The proposal risks continuation of a poor quality frontage along Queensway as shown below and may require more mitigation.

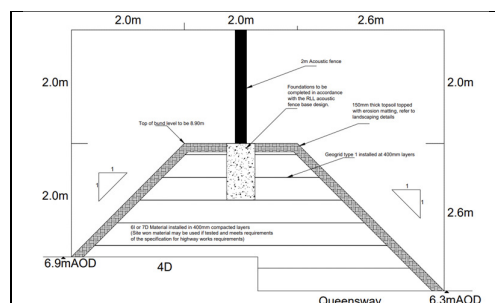
- Risk to the hedge planting being successful given the 1 in 1 slope [water will run-off rather than being retained].
- It is unclear where the hedge will lie in relation to the section.

- Hedge width at maturity or at target width needs to be factored in.
- It is unclear how water run-off will be picked up at the base before this reaches the footpath.

- I assume the hedge will be allowed to grow on but this needs to be confirmed, if not the target height and width is required and consideration of allowing some planting to grow on to vary the uniform approach along the approximately 240 linear meter frontage onto the A4810. A uniform hedge will simply highlight the linearity of the bund and fence rather than mitigate the impact, **widening out to a double or triple hedge at intervals** would help, potentially with ground cover planting along the base. Planting proposals should look to reflect the varied vegetation on the opposite side of the A4810.

- The engineering section shows topsoil held by erosion matting. The landscape proposals show bark mulch – I am fairly confident this will wash off onto the path.

- Run-off from the slope will also be an issue for rear gardens and note buildings highlighted are proposed immediately at the slope base.

I advise that sections are provided by the landscape consultant at different locations along the bund to clearly show the relationship between the acoustic fence, bund, native hedge, and adjoining uses/surfaces; that water run-off is factored in; and the proposal for planting and bark mulch is reviewed.
